Analyzer feedback to track-efficiency systematic

Figure 1: Relative error calculated between the two sets of track efficiencies.

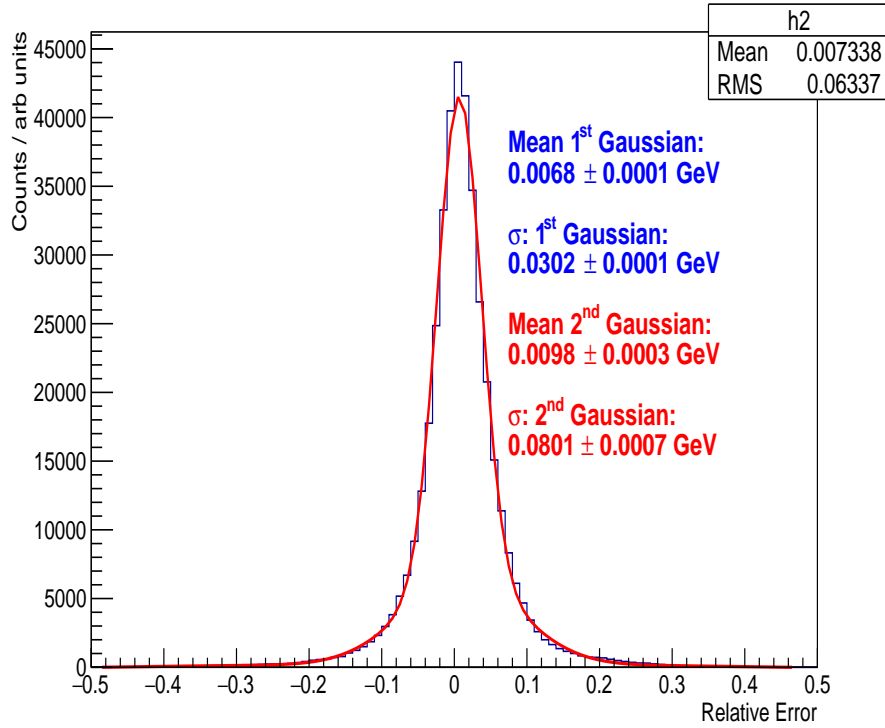
- b. Refused: As seen on the plot given above, the mean, as calculated by ROOT, which is as committee wants, is lower in value than the analyzer wants to report. Also this value does not statistically capture the true value of the correction.
- c. This comment by the committee is also incorrect. Also refused to use the RMS in quadrature because the RMS, is the error of the error.
